## Technical Bulletin

**Models:** Green Dragon

**Subject:** Gas Hose Change

*Figure 1 - 006051 Gas Hose Assembly*

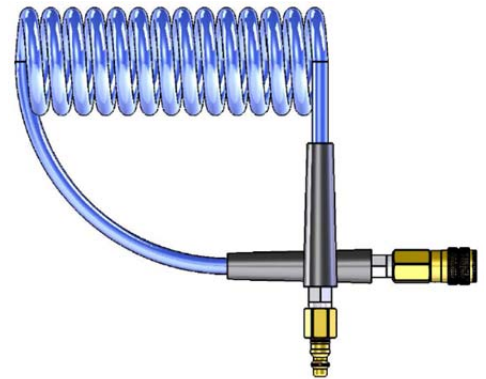
It has recently come to the attention of SEI that the specification for the gas hose used on the Green Dragon has changed. SEI was not informed by the supplier of the change at the time it occurred. The original hose (part number 006046) was rated for 150 psi at 70° F but has since been de-rated by the manufacturer to 130 psi at 70° F. The 130 psi hoses have the rating printed on the outside of the hose.

SEI has sourced a replacement hose (part number 011801) that will be included with all new Green Dragon PSDs. The new hose is used in the gas hose assembly (DE14910 or 006051) which will be available on warranty to all customers with the down-rated hose. Customers who purchased their Green Dragons after 2012 are expected to have the de-rated hose. Please contact your local service center for more information and the warranty replacement part.
